7.6 All Other Instrumentation Systems Required for Safety

The information in this section of the reference ABWR DCD, including all subsections, tables, and figures, is incorporated by reference with the following departures and supplements.

Figure 7.6-4a Basic Configuration of a Typical Neutron Monitoring System Division

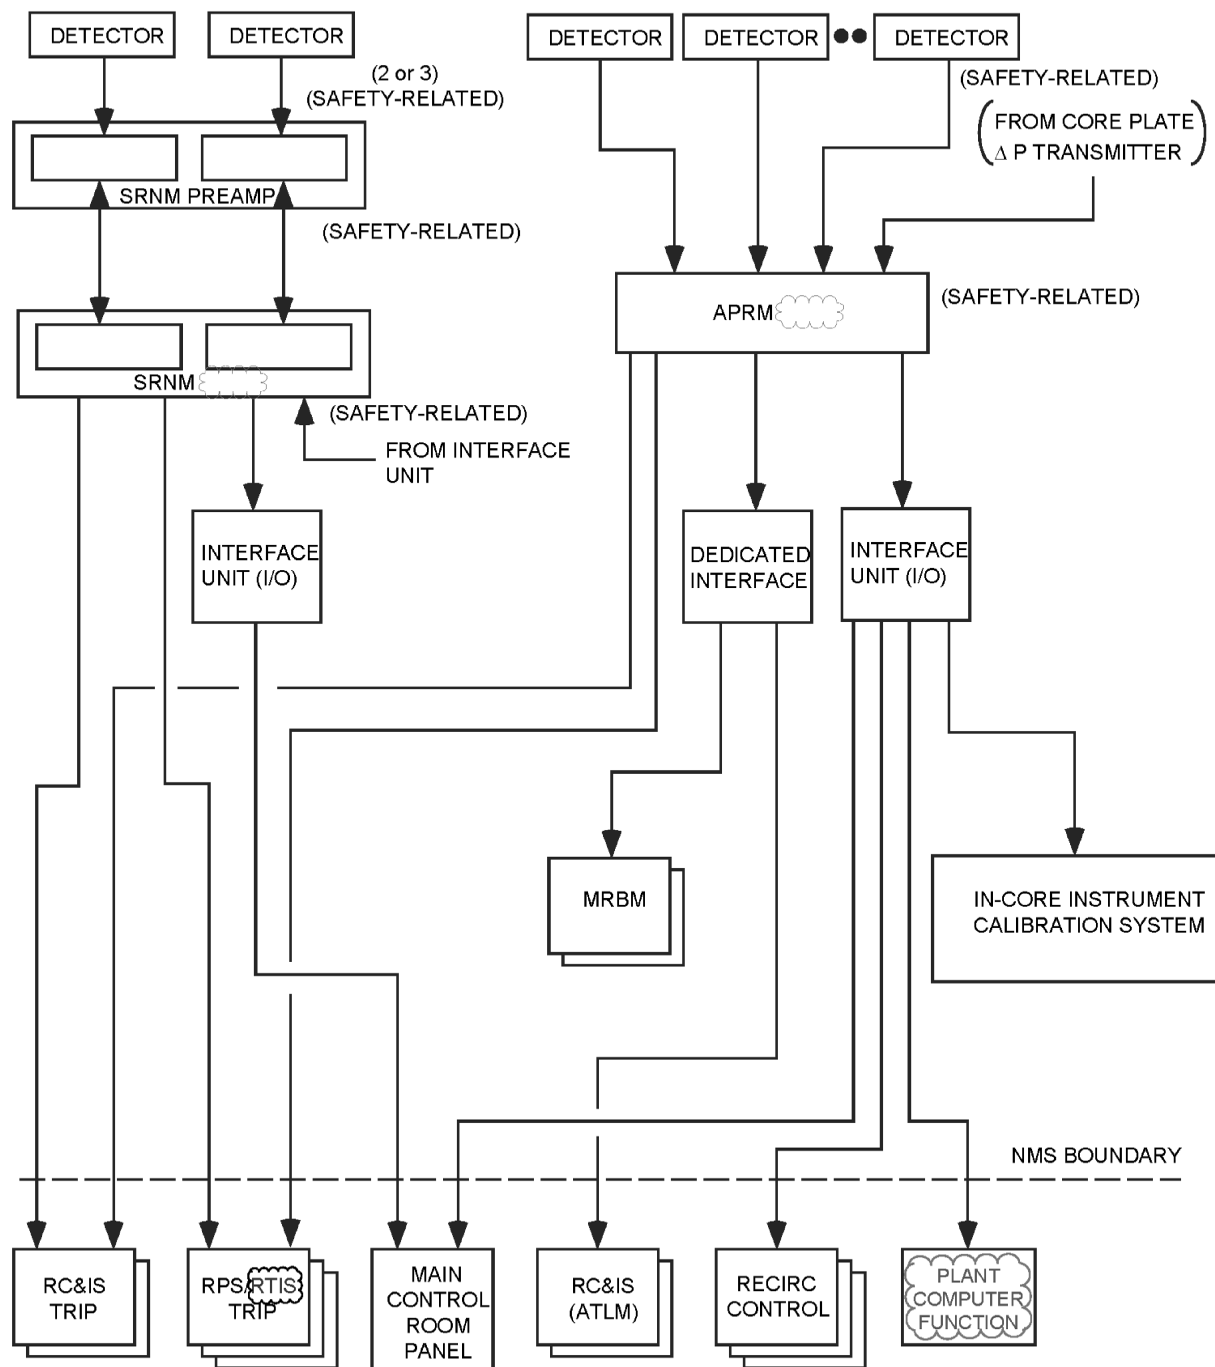
STD DEP T1 3.4-1 (Table 7.6-5 and Figures 7.6-1, 7.6-2, 7.6-4a)

The purpose of the Neutron Monitoring System (NMS) is to monitor power generation and, for the safety function part of the NMS, to provide trip signals to the Reactor Protection System (RPS) to initiate reactor scram under excessive neutron flux (and power) increase condition (high level) or neutron flux fast rising (short period) condition. The NMS also provides power information of operation and control of the reactor to the Plant ~~Process~~ Computer System (PCS) Functions (PCF) and the rod block monitor. A block diagram showing a typical NMS division is shown in Figure 7.6-4a. The operating ranges of the various detectors are shown in Figure 7.6-4b.

Figure 7.6-9 Instrumentation Location Definition for the Suppression Pool Temperature Monitoring System

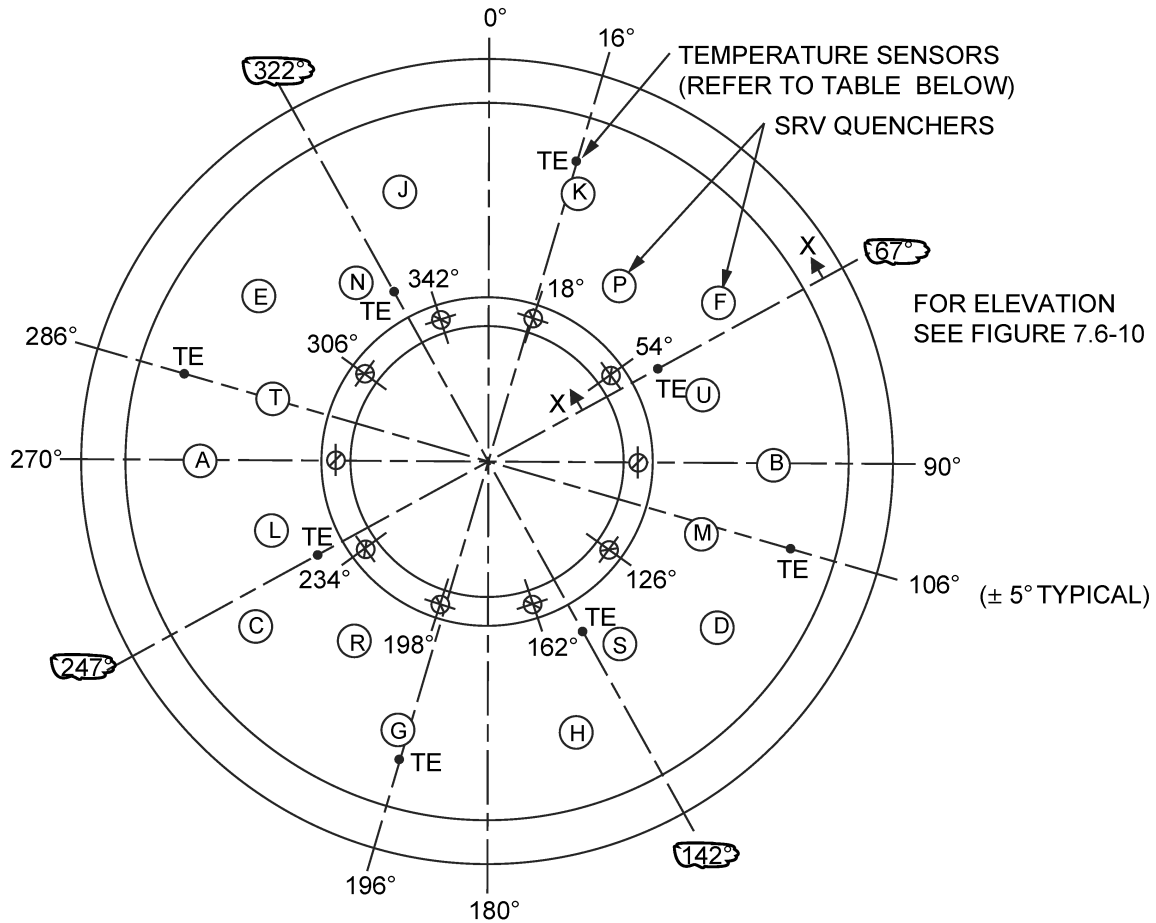
STD DEP 7.6-3 (Figures 7.6-9, 7.6-11)

STD DEP 7.6-3

The SPTM System configuration is shown in Figures 7.6-9 and 7.6-10. There are eight temperature circumferential sensor locations (Figure 7.6-9), which are chosen based upon the following considerations:

Figure 7.6-14 OPRM Logic

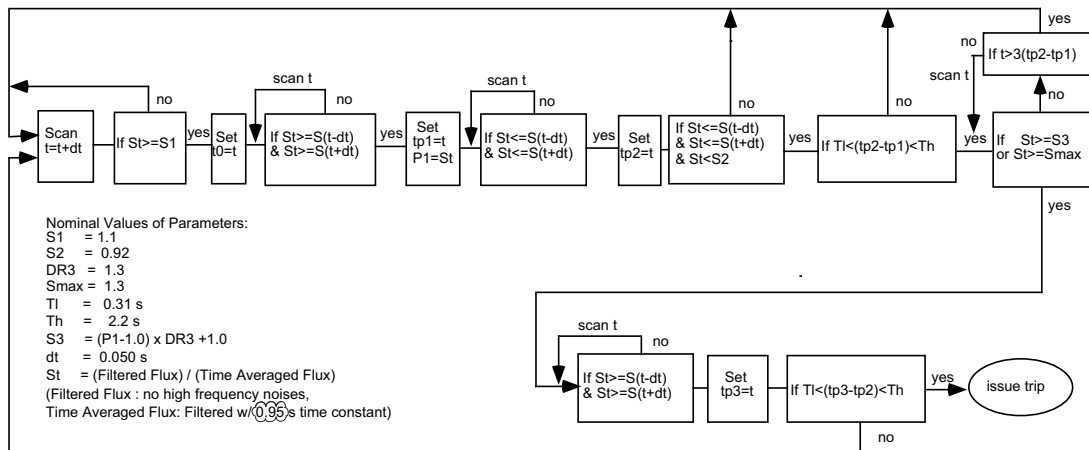
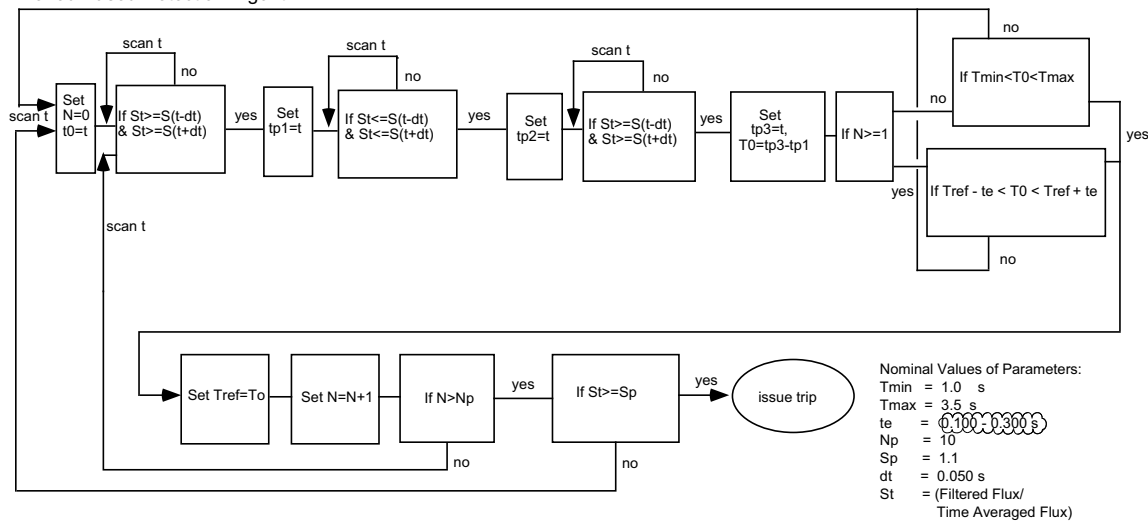
STD DEP 7.6-1 (Table 7.6-2 and Figures 7.6-2, 7.6-14)

For the OPRM trip function, the response signal of any one OPRM cell that satisfies the conditions and criteria of the trip algorithm will cause a trip of the associated OPRM channel. Figure 7.6-14 illustrates the trip algorithm logic. ~~The OPRM trip function does not have its own inoperative trip for insufficient number of total LPRM inputs in the channel. It follows the APRM's inoperative trip of insufficient number of LPRMs.~~ The OPRM function has its own inoperative trip when the channel has less than the required minimum operable cells, when there is an OPRM self-diagnostic fault, when the APRM instrument watchdog timer has timed out, or if there is a loss of power to the APRM instrument.
